## 19L ABWR Shutdown Risk Evaluation

The information in this appendix of the reference ABWR DCD, including all subsections, tables, and figures, is incorporated by reference with the following departures.

Figure 19L-3 Potential Path for Draining RPV Through Residual Heat Removal System (Pump On)

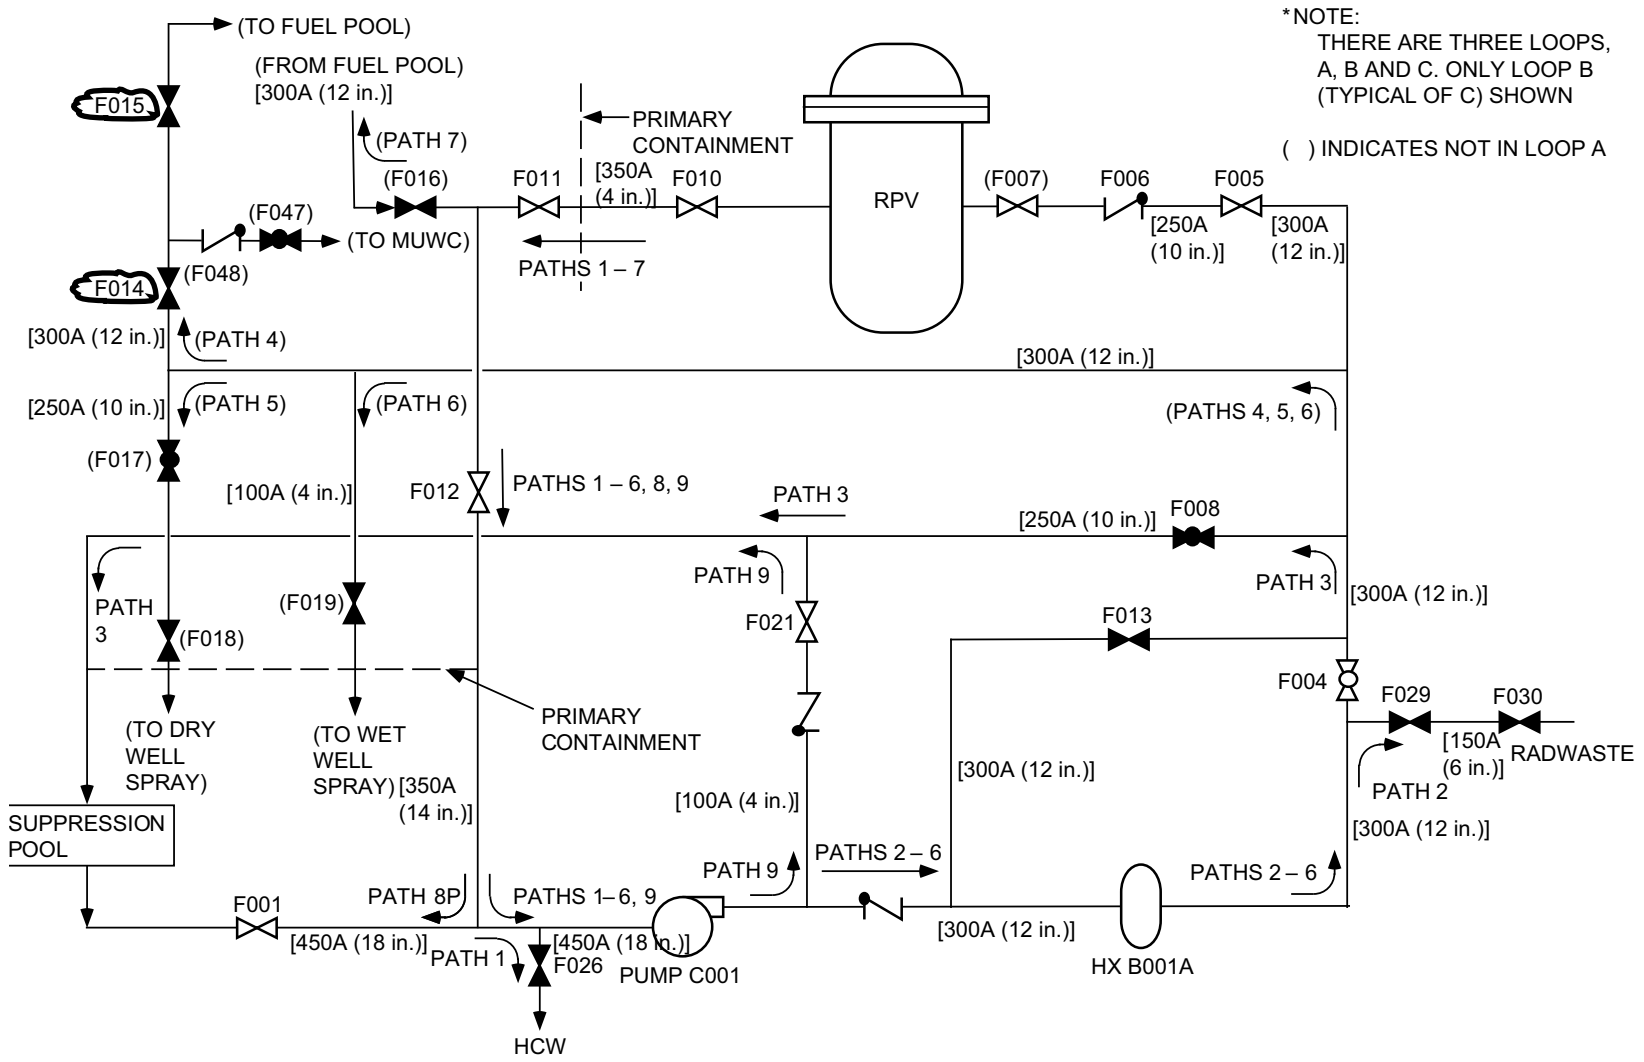
STD DEP T1 2.4-1 (Figure 19L-3)

STD DEP T1 2.4-1

*The ABWR residual heat removal (RHR) system is a closed system consisting of three independent pump loops (A, B, and C-where B and C are similar) which inject water into the vessel and/or remove heat from the reactor core or containment. Loop A differs from B and C in that its return line goes to the RPV through the feedwater line whereas loop B & C return lines go directly to the RPV. In addition, loop A does not have connections to the drywell or wetwell sprays. ~~or a return to the fuel pool cooling system.~~ However, for purposes of this analysis, the differences are minor and the three loops can be considered identical. The RHR system has many modes of operation, each mode making use of common RHR system components. These components are actuated by the operator; hence, the operation is subject to operator error which could potentially lead to drainage of the RPV. Potential paths for draining the RPV through the RHR system during operating Modes 4 and 5 are discussed below, summarized in Table 19L-8 and depicted in Figure 19L-3. Of the various modes of RHR operation it was judged that the potential for RPV draining was the greatest during the shutdown cooling mode. Therefore, the potential RPV draining paths start with the RHR in the shutdown cooling mode of operation. As will be shown by the following consideration and analysis, the probability of draining the RPV through the RHR system is negligibly low. Even if all the preventive and mitigative features fail, RPV draining will stop when the RHR shutdown cooling nozzle is uncovered at which point there is still 1.6 meters of water over the top of the active fuel.*

STD DEP T1 2.4-1

The residual heat removal (RHR) design will have three RHR loops connected to the fuel pool cooling and cleanup system (FPCCS) instead of two for the reference ABWR DCD with normally closed inter-ties to permit additional supplemental cooling during refueling outages to reduce outage time.

Increasing the number of RHR loops connected to FPCCS from two to three results in a decrease in CDF, because it is an improvement of the outage management control for the fuel pool cooling system.
